Addendum to the Environmental Impact Report

J Street Drain Project

SCH # 2008041057

December 2014

Figure 2-4. Construction Reaches 2 through 4

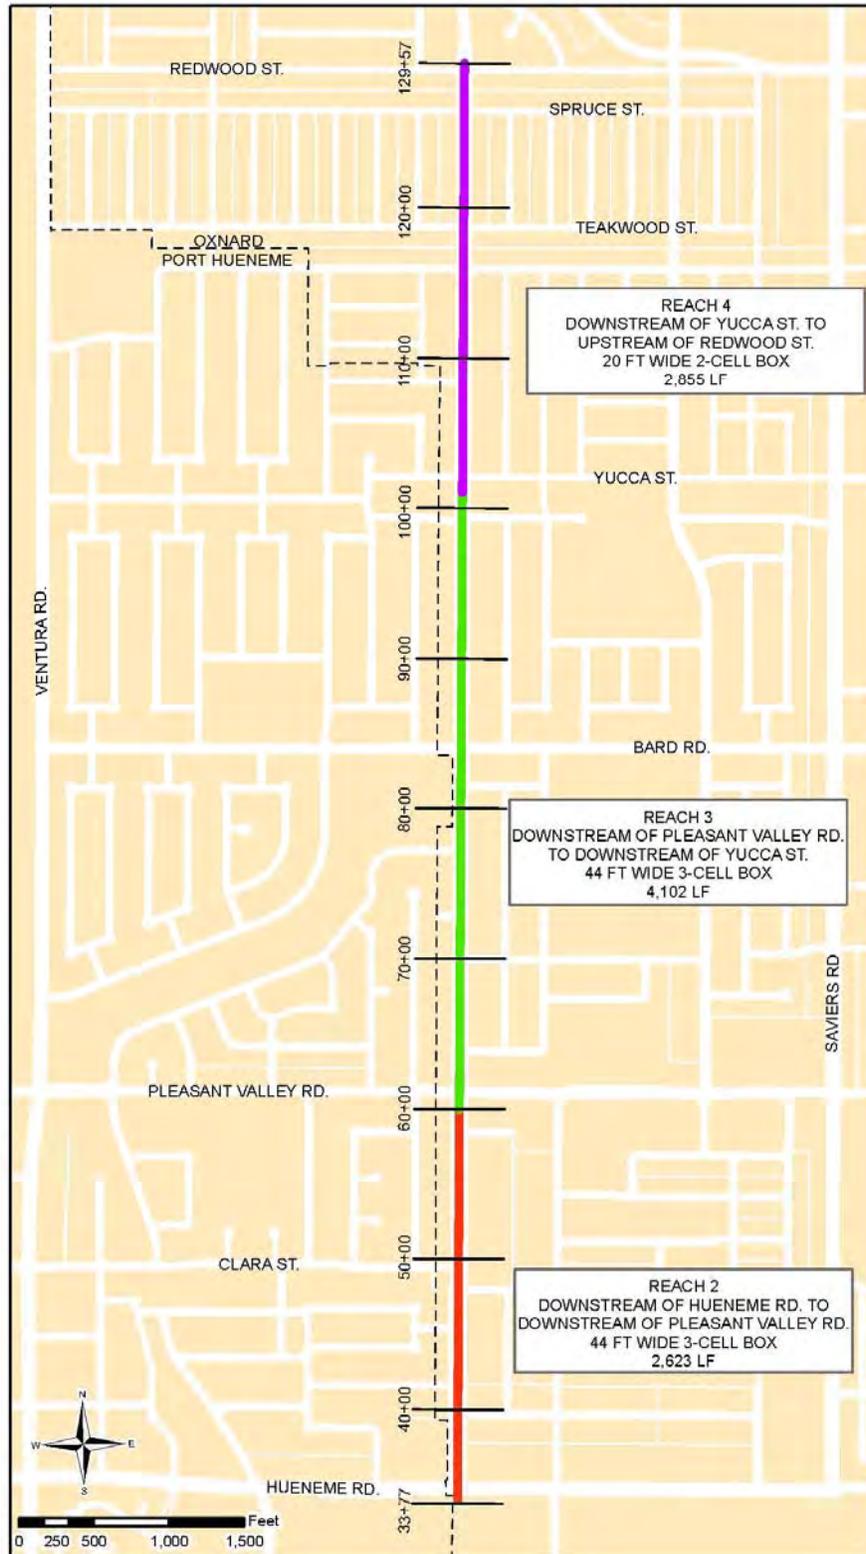
The proposed modified project would feature buried box culverts that would allow for landscaping on top. Similar to the approved project, the channel would remain open in Reach 1 from the south side of Hueneme Road south to Ormond Beach Lagoon (Figure 2-3) to avoid impacts to endangered species in the lagoon.

Figure 2-5. Cross Section of Three-Cell Buried Box Culvert Design

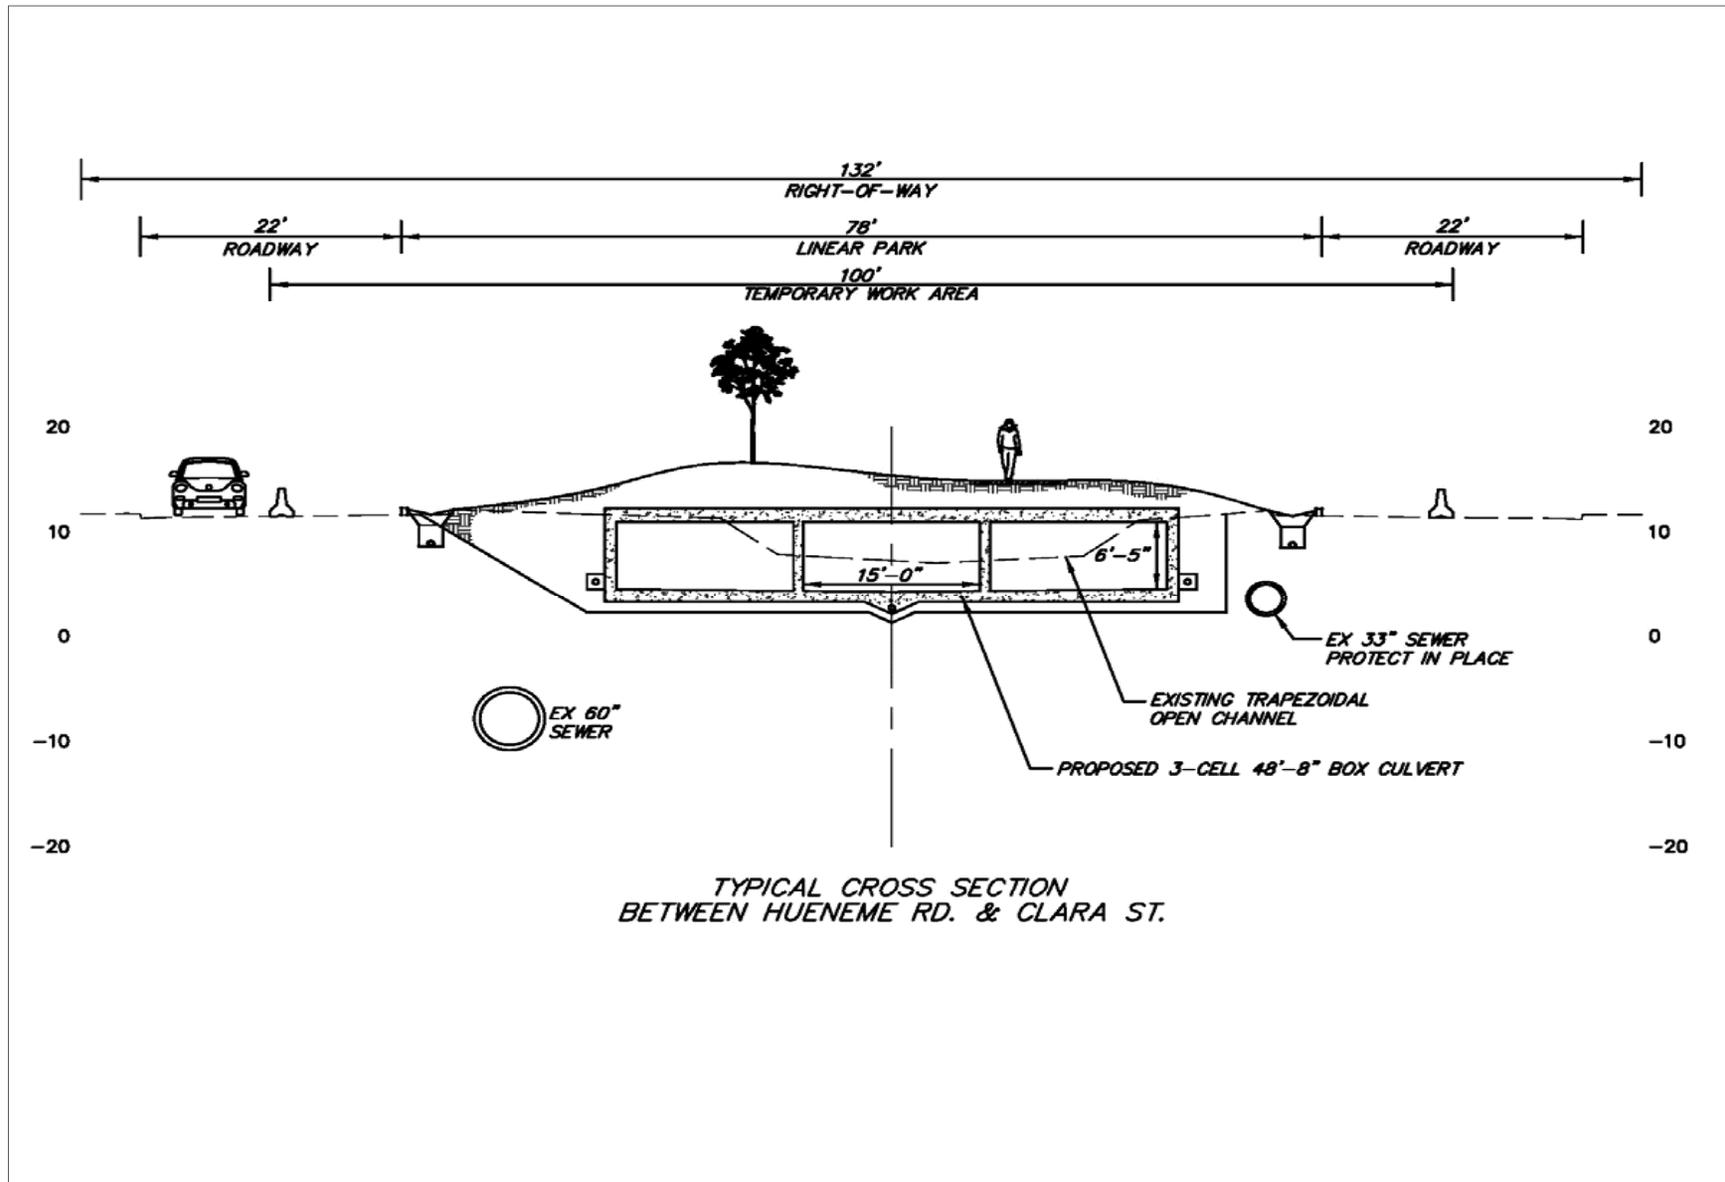
Phase 1 is currently being constructed as approved on March 27, 2012 and therefore no changes would occur under the proposed modified project. Phases 2 and 3 would include the construction of three-cell box culverts that are 44-foot wide and 7-foot high from Hueneme Road to Yucca Street. Phase 4 would include the construction of two-cell box culverts that are 20-foot wide by 6.5-foot high from Yucca Street to just north of Redwood Street (Figure 2-4). Figure 2-5 depicts a cross section of the three-cell buried box culvert design. Manholes would be located every 500 feet to address maintenance and vector control issues.
